Docket Number:	14-AAER-02
Project Title:	Computer, Computer Monitors, and Electronic Displays
TN #:	211618
Document Title:	ITI/TechNet Comments on Computers
Description:	N/A
Filer:	System
Organization:	ITI/TechNet
Submitter Role:	Public
Submission Date:	5/23/2016 5:08:37 PM
Docketed Date:	5/24/2016

ITI/TechNet Comments on Computers

CEC Final Draft Staff Report for Computers (Docket #14-AAER-2)

ITI/TechNet Comments on CEC Staff Report
May 23, 2016

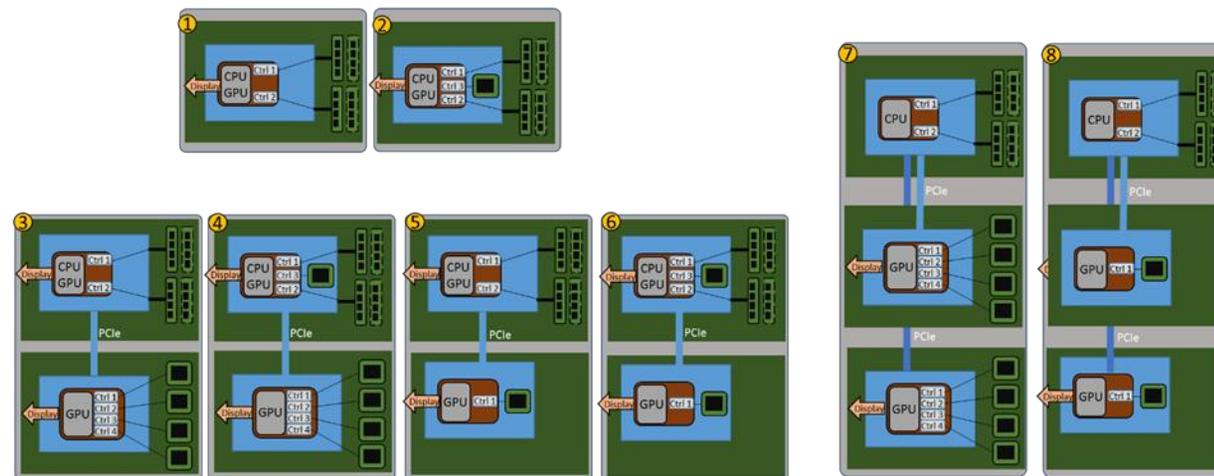
Due to the co-existence of both topologies (Refer to the topologies in Figure 1) in the market, we propose a holistic *System Memory Bandwidth (SYS_MEM_BW)* additive approach that accounts for growth in memory bandwidth in either integrated or discrete graphics implementations. Systems with discrete graphics can continue to use traditional discrete GPU adders. We propose a new class of TEC adders based on system memory bandwidth (see below) that applies to all systems, and covers system memory bandwidth and associated CPU/APU/SOC.
